Runwood Homes

The Whitecroft Care Home,
Stanford Road, Orsett, GRAYS, Essex

Project Reference: 2212-030/TN/01/B

Technical Note – Impact of Lower Thames Crossing Construction Traffic on The Whitecroft Care Home

Figure 5 Haul road 3a (between the Station Road and Brentwood Road compounds) haul road 4 (between Brentwood Road and the Stanford Road compounds)

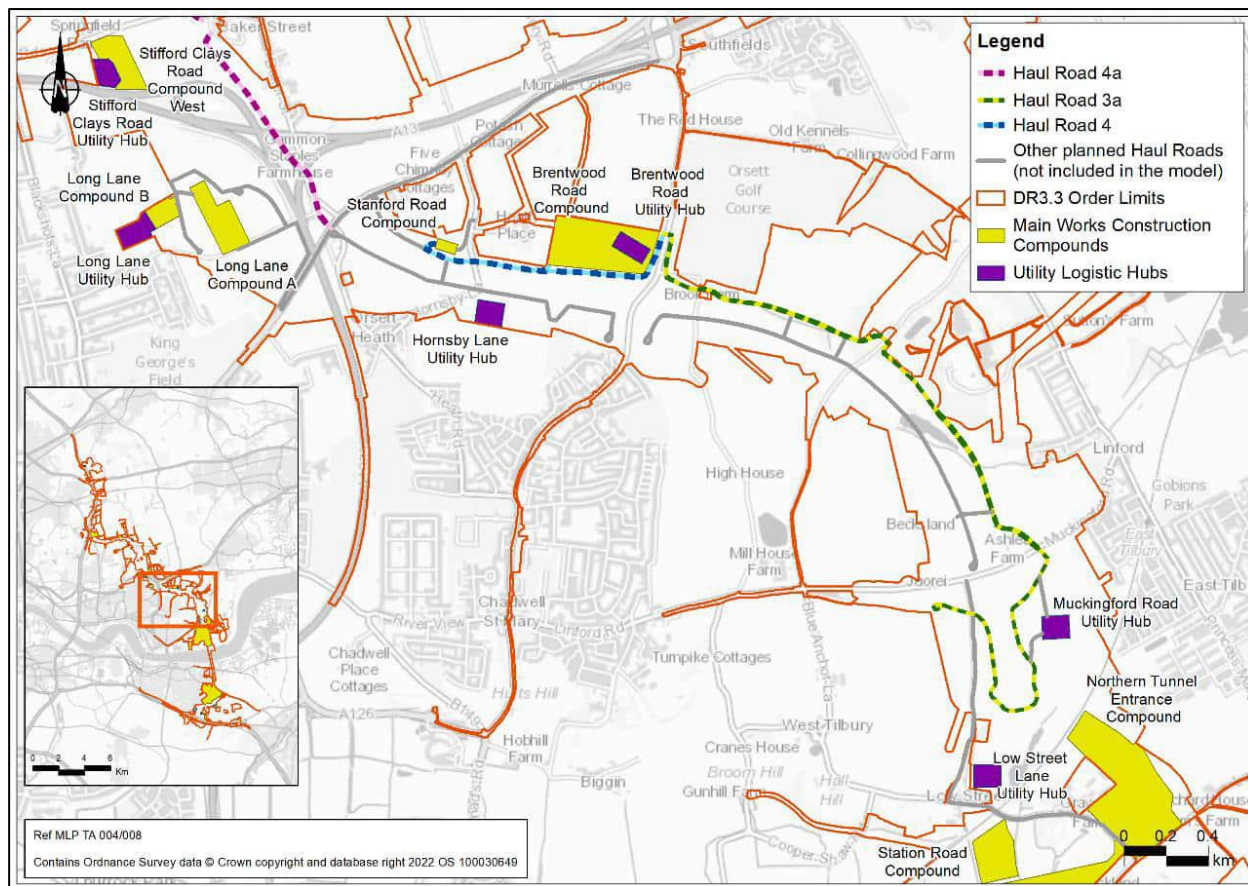
- 3.27 It should be noted, however, that the 'Stanford Road Compound' lies southeast of The Whitecroft, and Plate 8.8 (**Figure 5**) clearly identifies the provision of a haul road west, south and southeast of The Whitecroft (The Stanford Road Compound Northern Haul Road) that is referred to in the 'Legend' as: 'Other planned Haul Roads (not included in the model)'.

- 3.28 It also indicates that Stanford Road (in the vicinity of The Whitecroft) is intended for use as a haul road that, similarly, is not included in the model.

- 3.29 As I discuss below, this section of haul road does not, in my view, accord with National Highways' definition insofar as it does not provide a link between the 'Stanford Road Compound' and the public highway. It appears to be a cul-de-sac with a turning loop that extends from the western end of Haul Road 4 at the compound north-westwards towards a realigned A1013, Stanford Road (but not intersecting with it).

- 3.30 It is not clear, in fact, or explained anywhere that we have been able to locate what purpose it serves or what types of construction vehicles will use it.

Figure 6 The haul road in the context of The Whitecroft

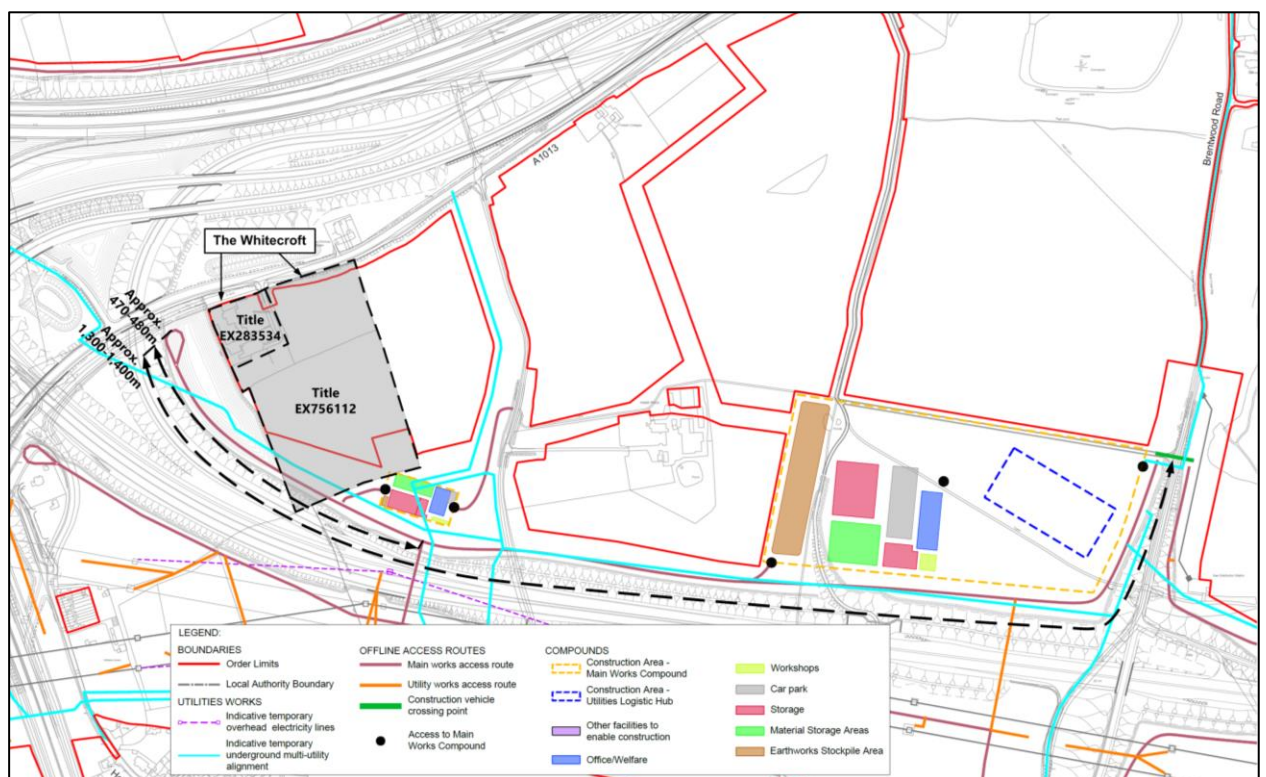
3.34 That clearly shows a length of ‘Main works access route’ (haul road) (approximately 1,300-1,400m long, measured from its connection with Brentwood Road at its eastern end) running north-westwards from the ‘Stanford Road Compound’ towards Stanford Road crossing Title Number EX756112 and terminating at what appears to be a large radius turning circle/ head. It does not intersect with Stanford Road (so it does not accord with National Highways’ own definition of ‘haul road’) and I reiterate, its purpose is not obvious or clear.

3.35 That said, and on the basis that a similar length of haul road is proposed on the south western side of the A122, I think that it is reasonable to assume that this length of haul road is required for the construction of

the bund proposed between The Whitecroft and the A13 westbound slip road to the A122 Lower Thames Crossing southbound and, perhaps, the earthworks required to form the embankment shown on the eastern side of that slip road.

- 3.36 Interestingly, and in the 'Legend', National Highways does not differentiate between 'Haul Road 4' and 'Other planned Haul Roads (not included in the model)', as it does in Plate 8.8 of the *Transport Assessment*. Instead, the 'Legend' on Temporary Works Plan 29 simply refers to 'Main works access route'.
- 3.37 It should be noted that an 'Indicative temporary underground multi-utility alignment' for Work No. MUT13 runs approximately parallel (and east) of the proposed haul road, similarly crossing Title Number EX756112.

Figure 7 Haul Road 4 and Stanford Road Compound Northern Haul Road – Link ID 34

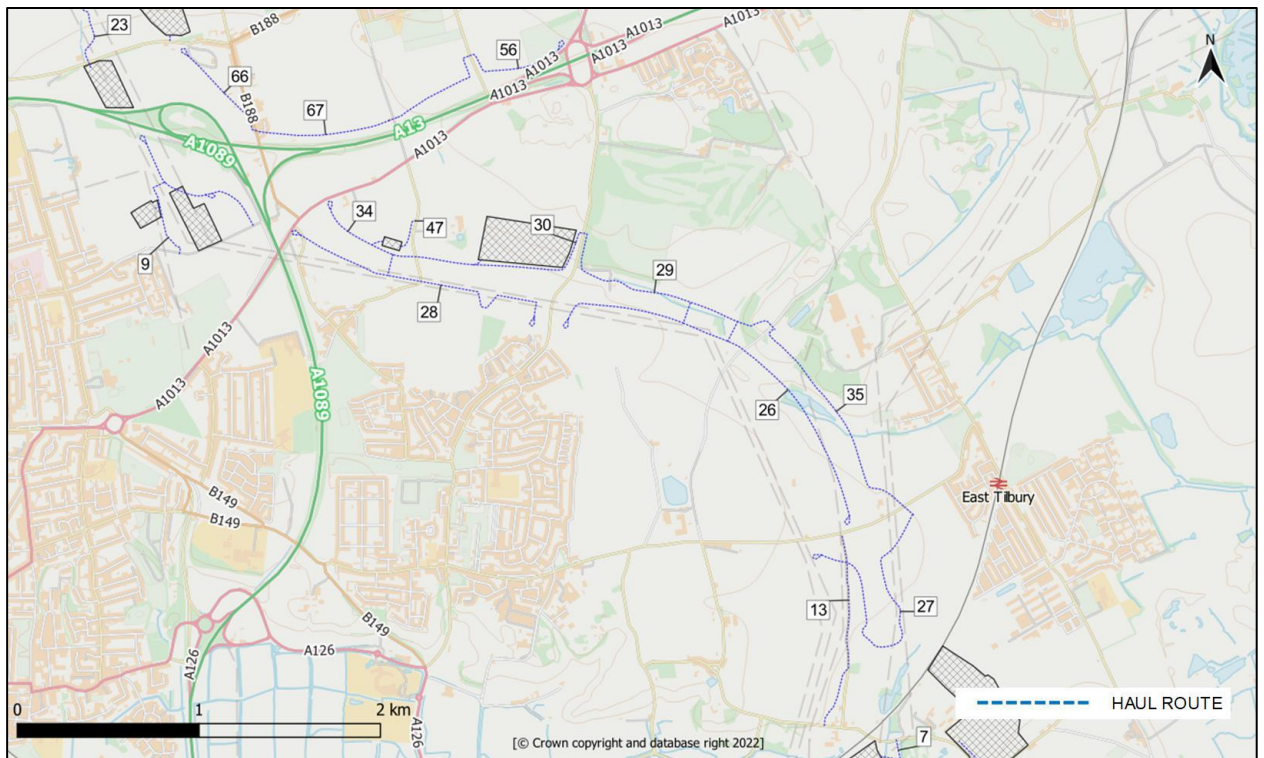
- 4.14 Notwithstanding that Haul Road 4 and The Stanford Road Compound Northern Haul Road are separately identified in the Transport Assessment⁷⁵, they are combined and identified as Link 34 in Plate 2.3, *Haul Route Locations* of Appendix 12.4 – *Construction Noise and Vibration Assessment* to the *Environmental Statement*⁷⁶ (reproduced in **Figure 7** overleaf).

4.17 It is apparent from my Table 1 that Haul Road 4 and The Stanford Road Compound Northern Haul Road (adjacent to The Whitecroft) will be in daily use for a continual period of four years and four months. That use commences at ‘Construction Month 9’ with 10 construction vehicles per day, rises and peaks during ‘Construction Month 28’ to ‘Construction Month 32’ with 121 constructions vehicle per day (for five months) and then declines to ‘Construction Month 56’ to ‘Construction Month 60’ to 1 construction vehicle per day. What is not clear is whether, or not, there is any differentiation between construction vehicle traffic on Haul Road 4 and on The Stanford Road Compound Northern Haul Road.

4.18 The daily/ weekly construction vehicle flow profile is not provided (so it is not possible to determine whether the flow of construction vehicles is evenly spaced out during the day, evening, night (during weekdays and at weekends), or whether they are platooned during specific time periods).

Figure 11 Proposed General Arrangement in the vicinity of The Whitecroft

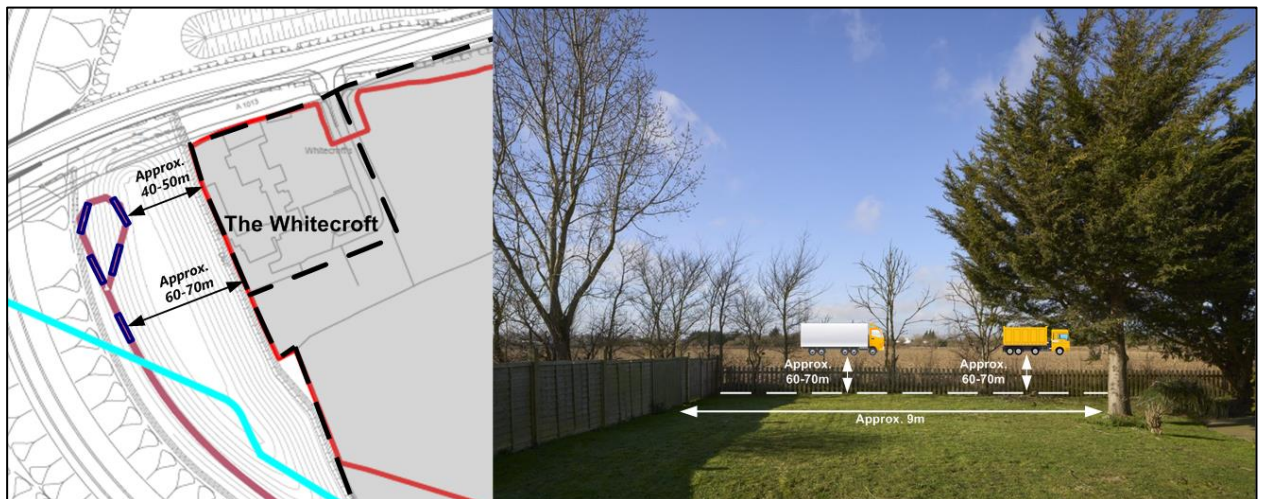
- 4.22 Similarly, National Highways does not provide the vertical alignment of the haul road or a cross-section (such as A-A marked on Figure 10 above) so it is not clear, therefore, whether or not, the existing westerly view from The Whitecroft will include sight of the haul road. It is, however and in my view, reasonable to assume that it will include sight of the construction vehicles trafficking it.

- 4.23 In an effort to gain an understanding what that impact may be, we have produced **Figure 11** (using a plan and a picture submitted as part of the DCO) illustrating HGVs using the haul road immediately west of the site.

Status	DCO Application	Original Size	Revision
Application Document Number	TR010032/APP/2.17	A1	P02
Drawing title	TEMPORARY WORKS PLANS REGULATION 5(2)(j) SHEET 29		
Drawing Number	HE540039-CJV-BOP-SZZ_GN000000_-DR-CW-70026		
		Scale	1:2500

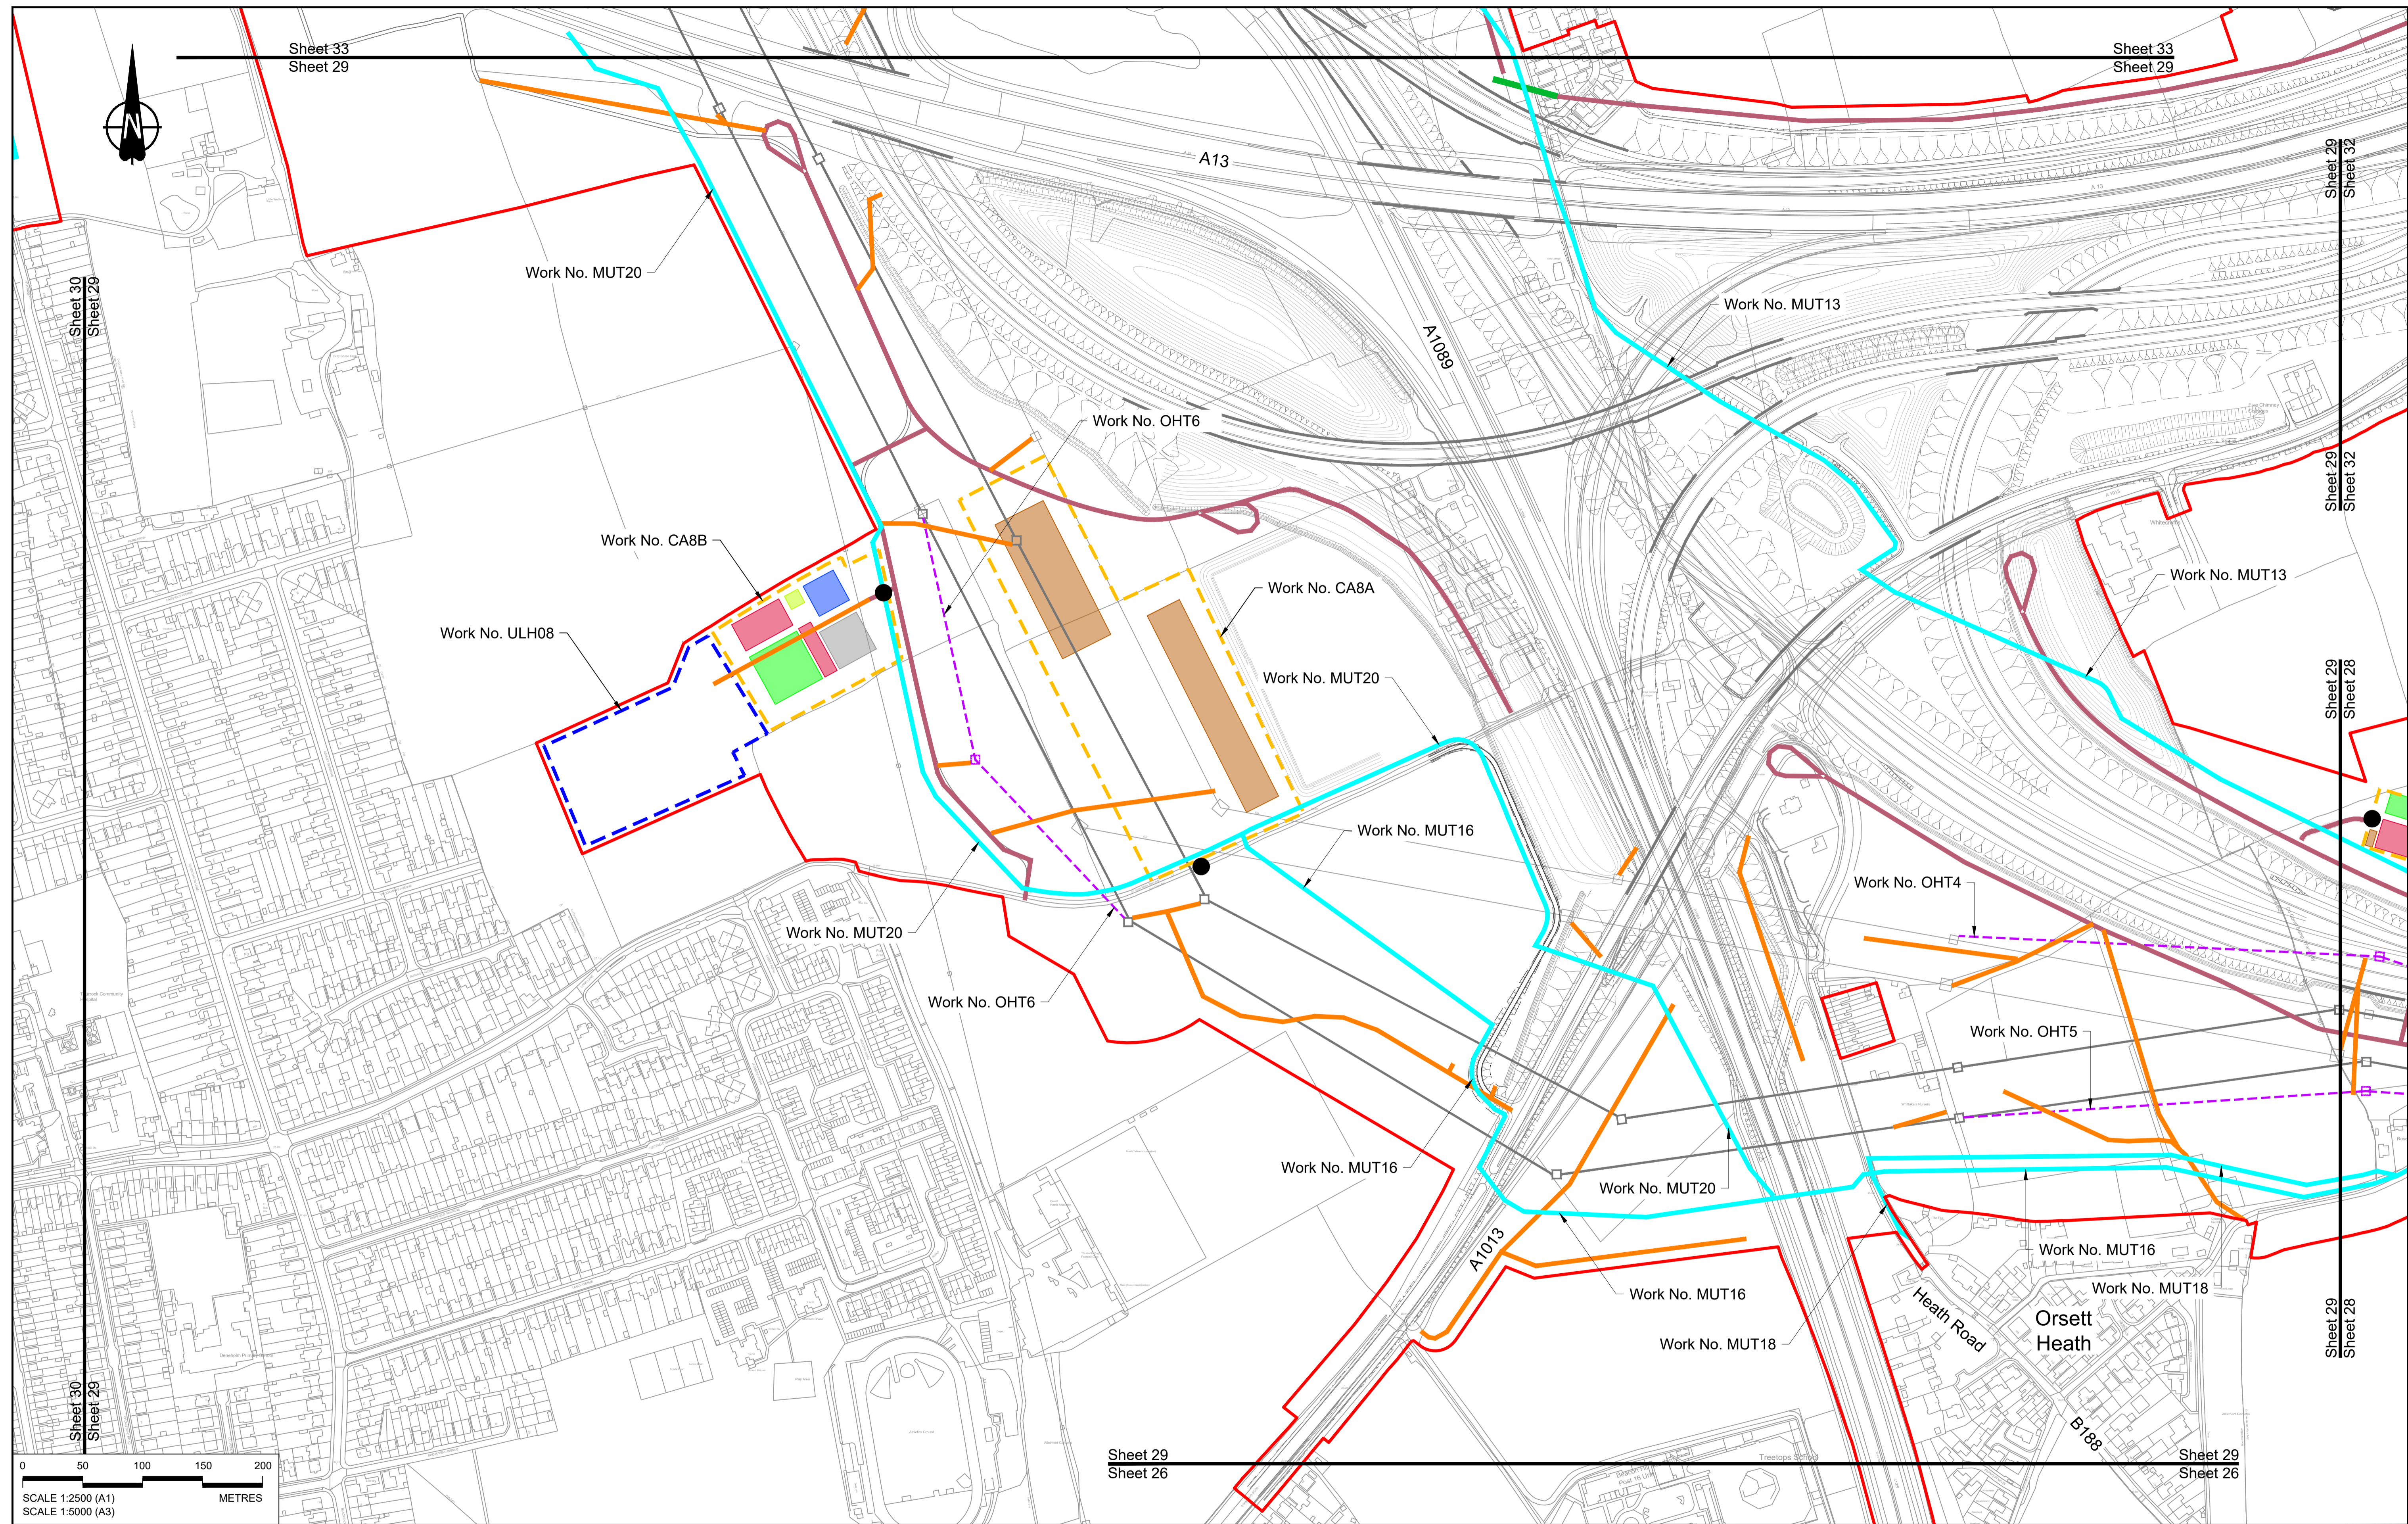
- 3.31 This section of haul road is illustrated at a larger scale in National Highways' *Temporary Works Plans, Regulation 5(2)(j), Sheet 29* drawing (number HE540039-CJV-BOP-SZZ_GN000000_-DR-CW-70026, Revision P02, dated 19 October 2022) (Temporary Works Plan 29) [**Appendix A**].
